- a. Consider a request for a Site and Design Review and a Minor Land Partition  
Applicant proposes to partition a lot with an existing home into two parcels and develop the vacant lot with two apartment buildings with a total of 8 units, located at 203 SW 3<sup>rd</sup> Ave. **(DR 18-01/MLP 18-01 Tievoli Apts. Jason Bristol).**

**SITE AND DESIGN REVIEW/MINOR PARTITION STAFF REPORT**

**FILE #: DR 18-01/MLP 18-01**

**Prepared for the March 12, 2018 Planning Commission Meeting**

**A1.1**

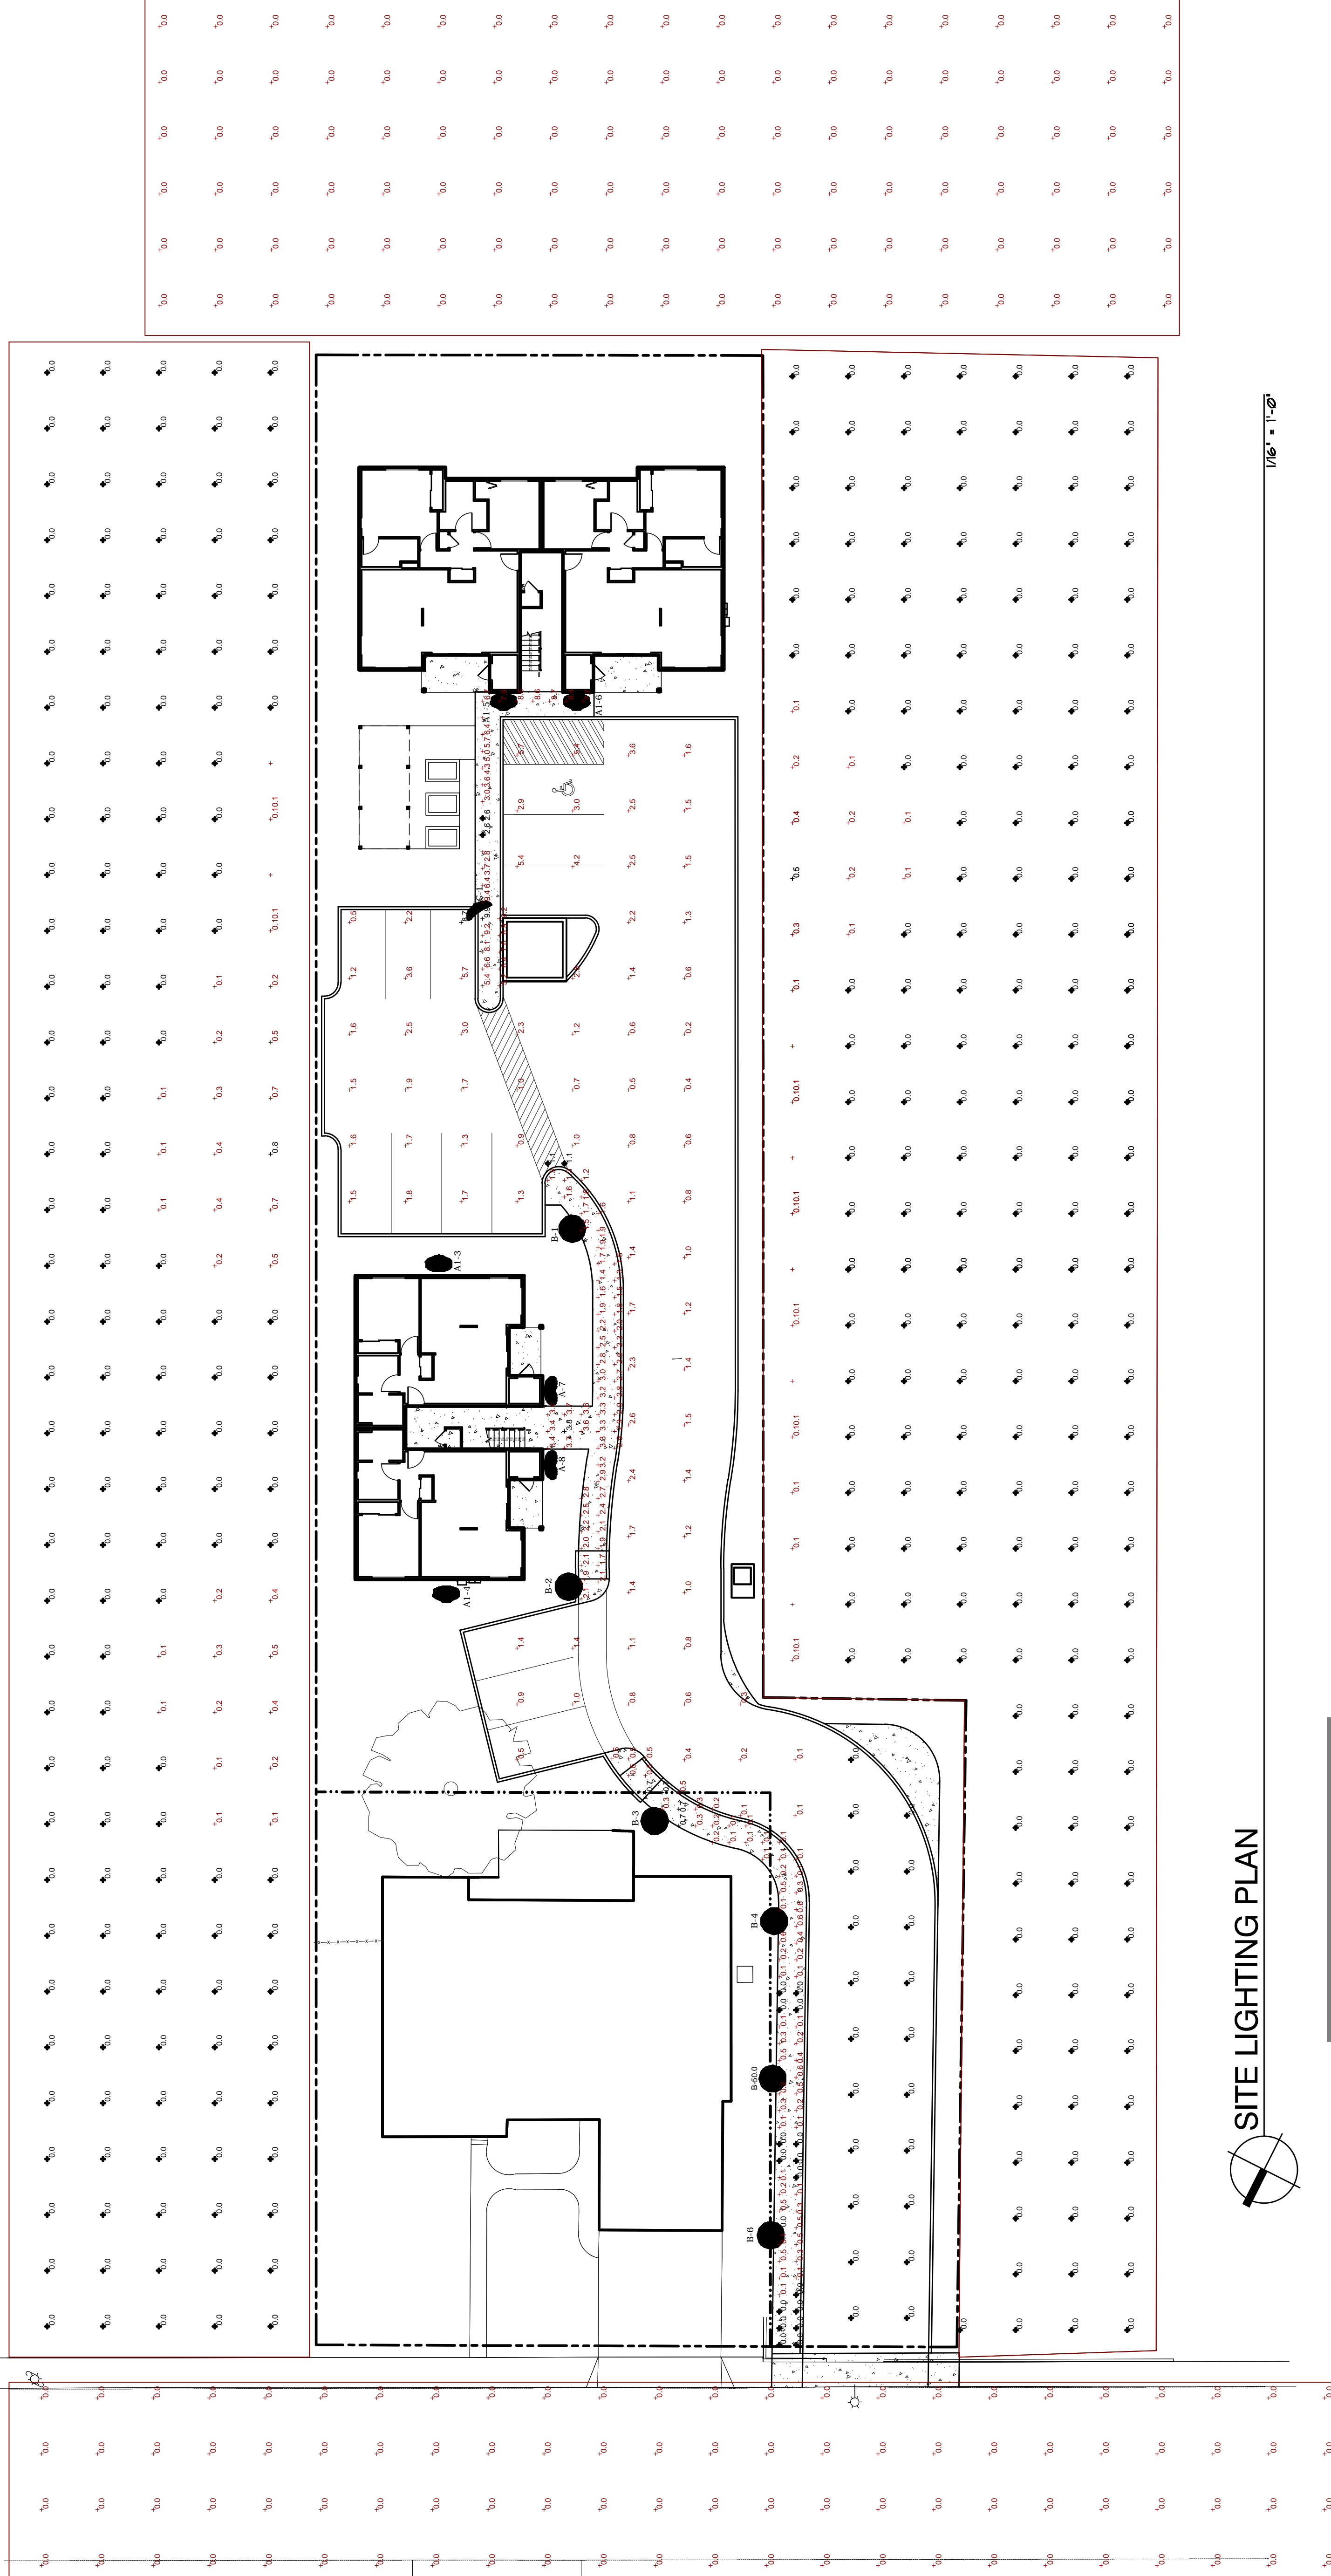
**Findings:** The applicant is required to provide one bicycle space per living unit for a total of eight spaces required for this eight-unit development. The applicant did not delineate bike spaces or racks on any of the submitted drawings, but the applicant mentioned in an email that hanging bike racks on patios may be placed at a later date. As a condition of approval, the applicant must designate eight bike spaces or racks for the development on the official site plan.

2. The applicant must designate eight bike spaces or racks for the development on the official site plan.
3. The applicant shall provide an irrigation plan at the hearing or prior to proceeding with construction of the project.

**SITE LIGHTING PLAN**

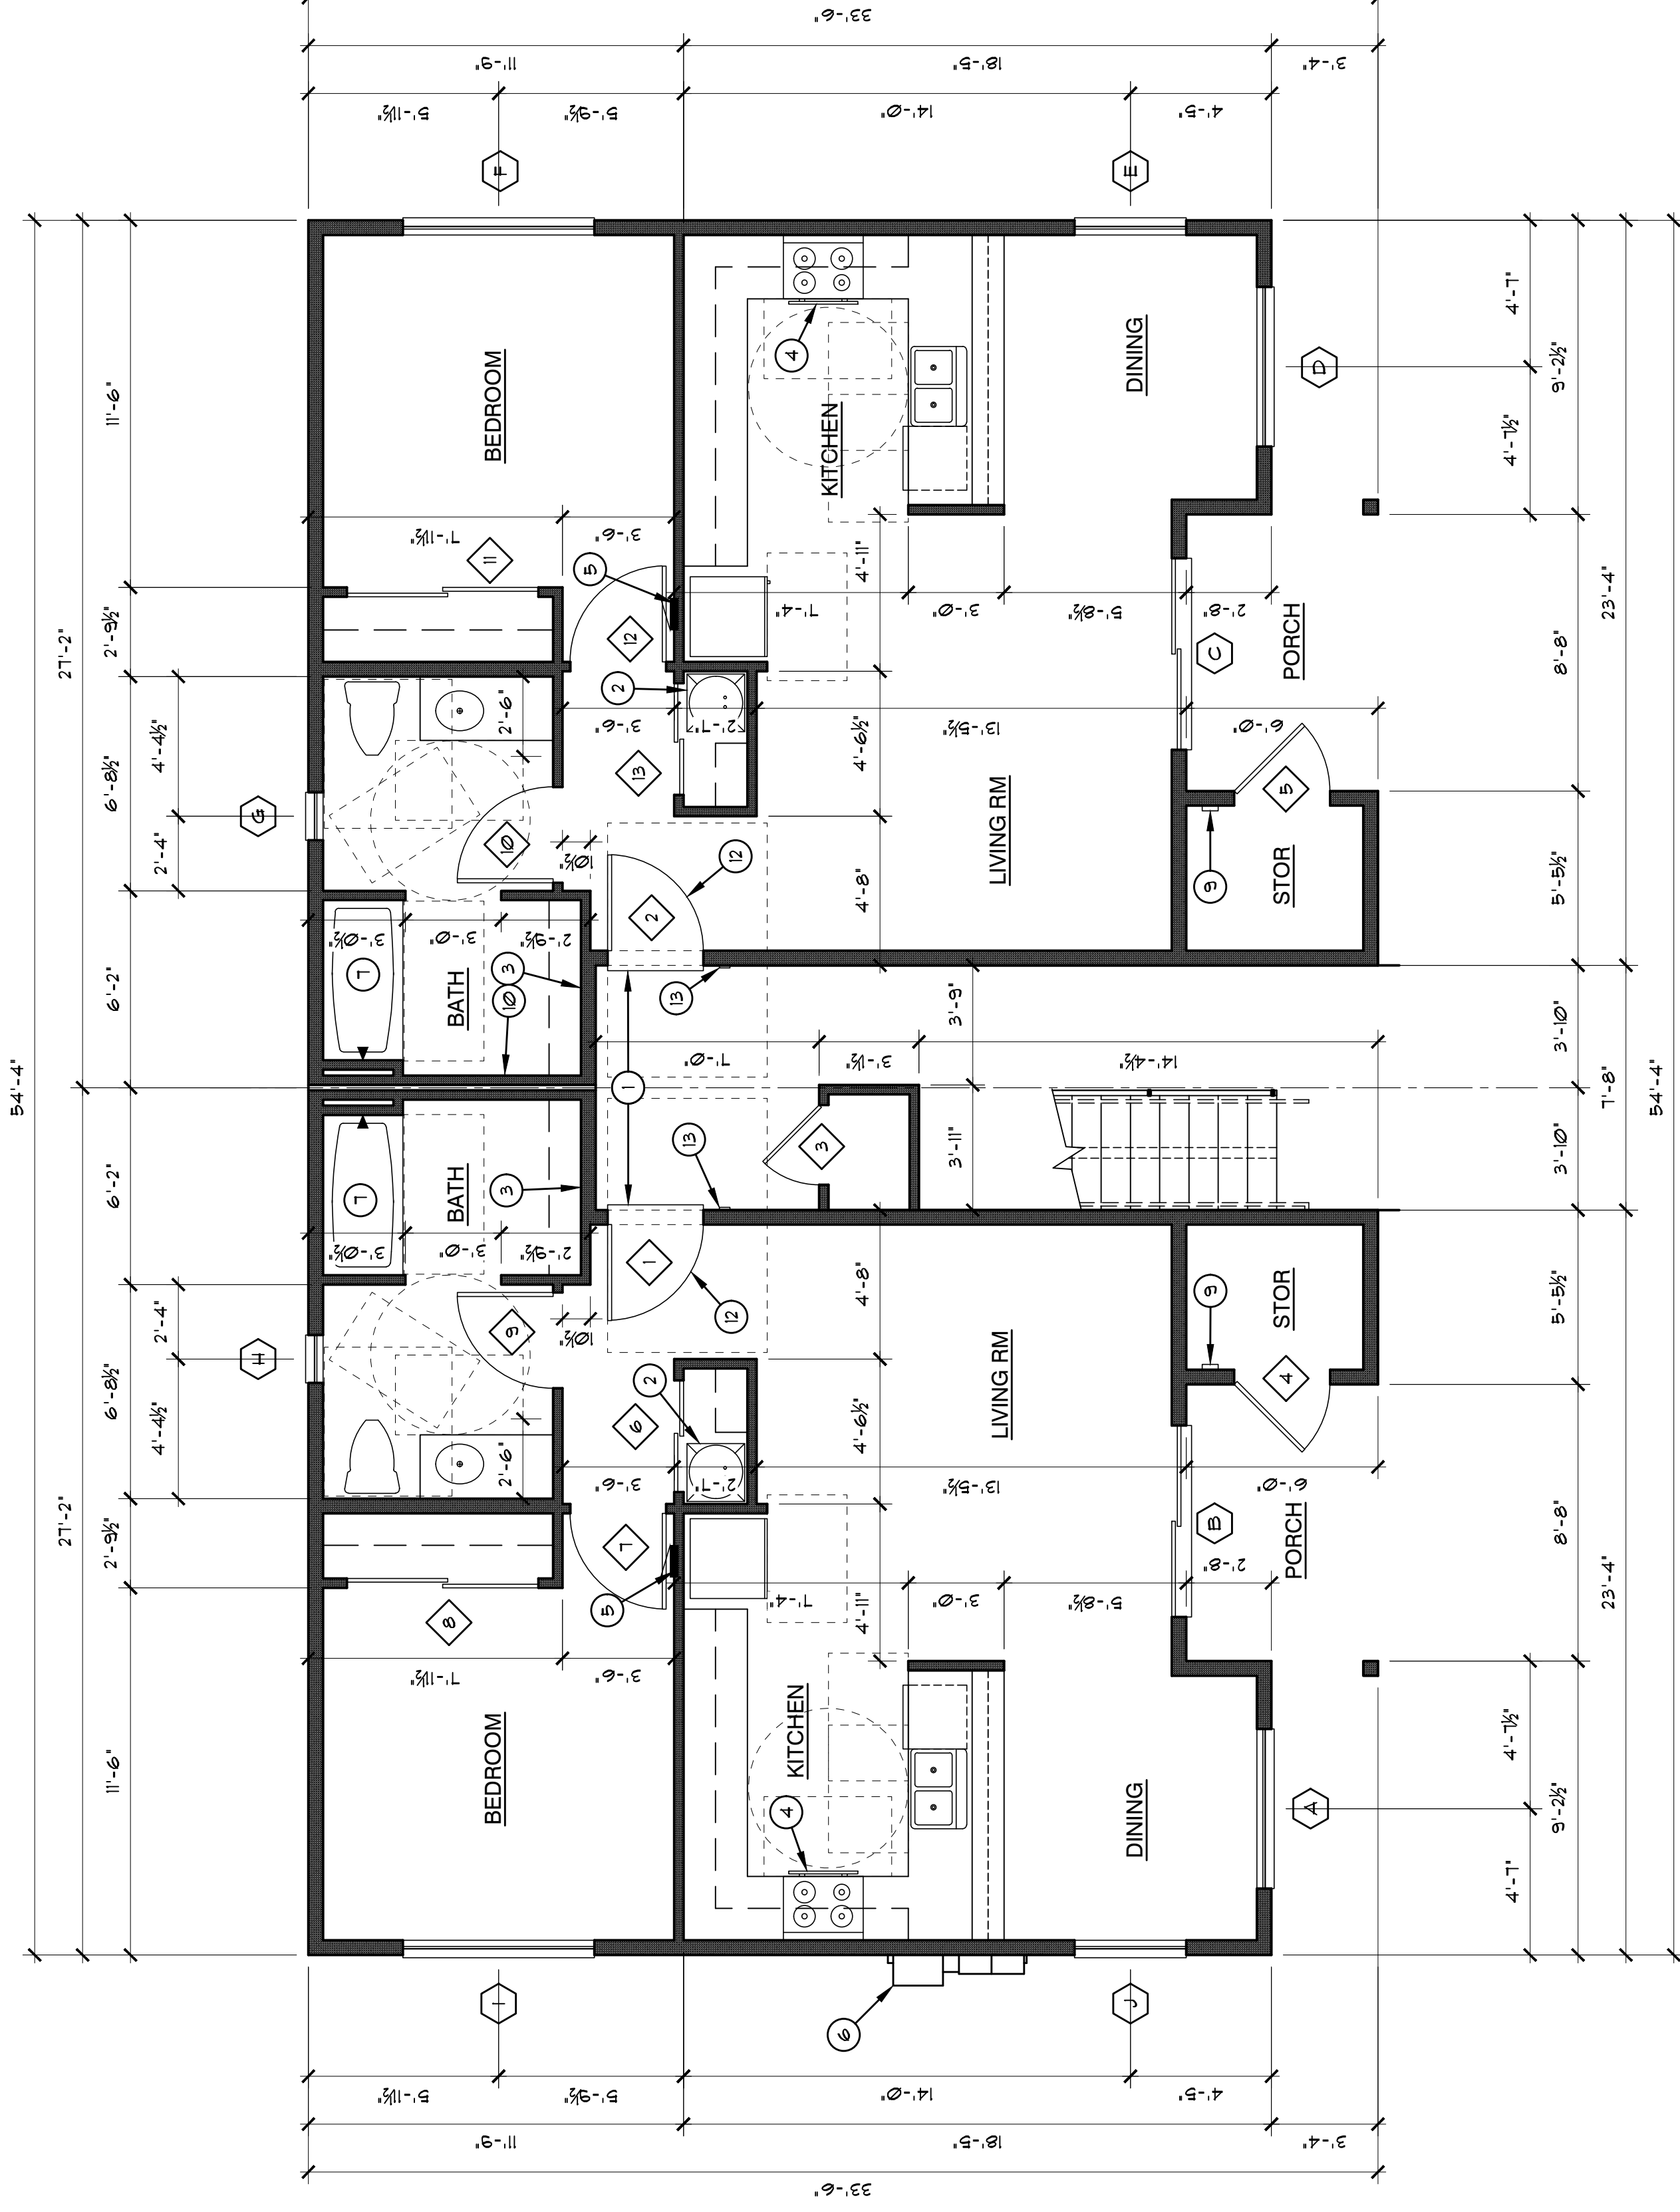
**Findings:** The applicant responded to criteria of this section and stated that the project will meet lighting standards. Cut sheets are required and a photometric lighting plan that indicates uniform lighting across the site that is to be shielded to avoid light trespass across the adjacent property lines and to prevent glare toward the street. The applicant submitted a site lighting plan that provided specifications of the fixtures and lumen information to allow full assessment of conformance with lighting standards.

LANDSCAPE PLAN 1/8" = 1'-0"

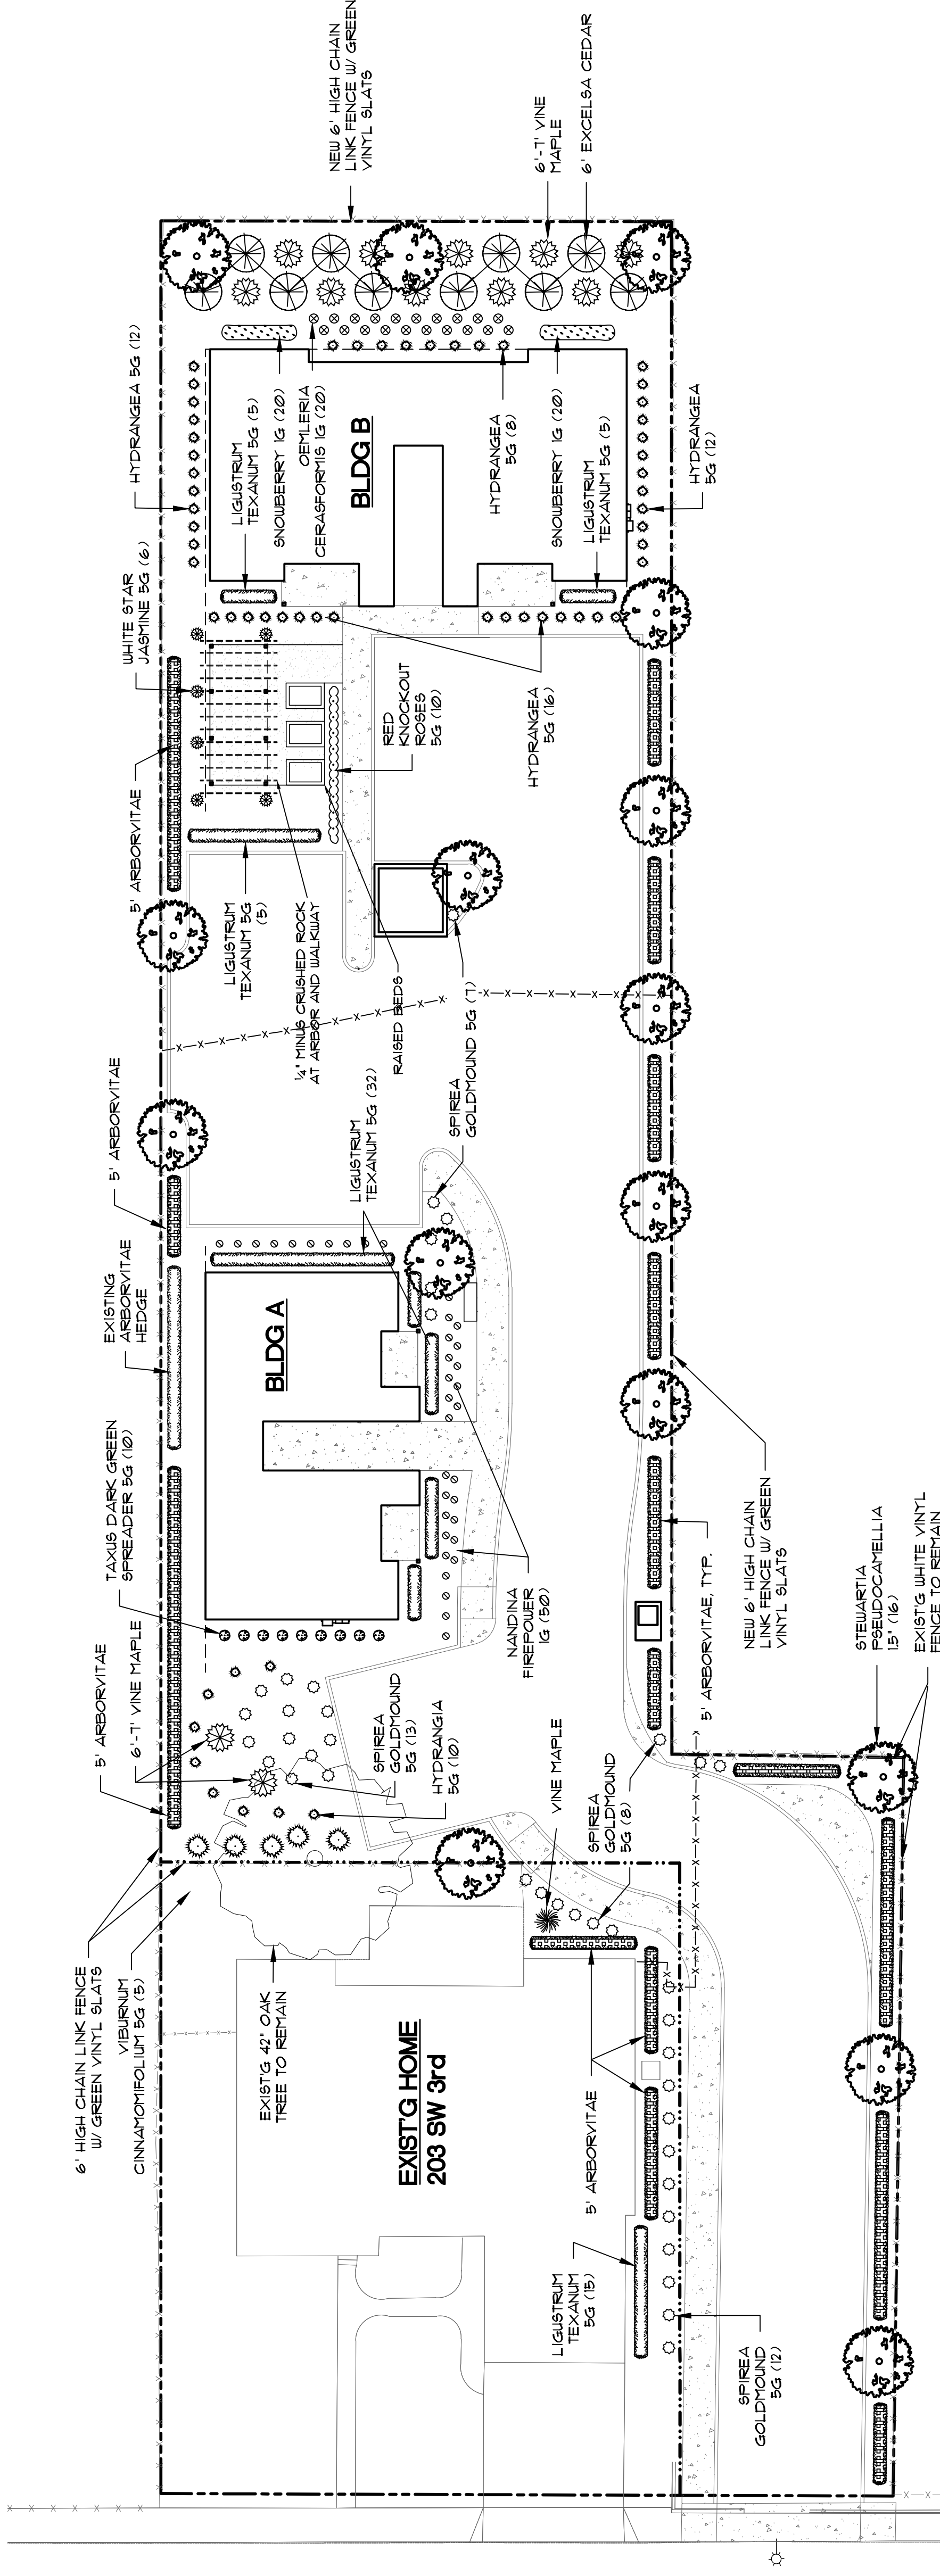
**Findings:** The applicant provided a landscape plan and detailed landscaping calculation to address planting and landscape provisions listed in this section. The plan identified the type of plants and ground cover in open areas and arborvitae along the outdoor parking area. Based on the information provided, the proposed landscaping meets requirements and percentages and appears to incorporate Low Impact Development (LID) techniques with storm water management. However, an irrigation system was not discussed or delineated on the landscape plan. As a condition of approval, the applicant shall provide an irrigation plan at the hearing or prior to proceeding with construction of the project.
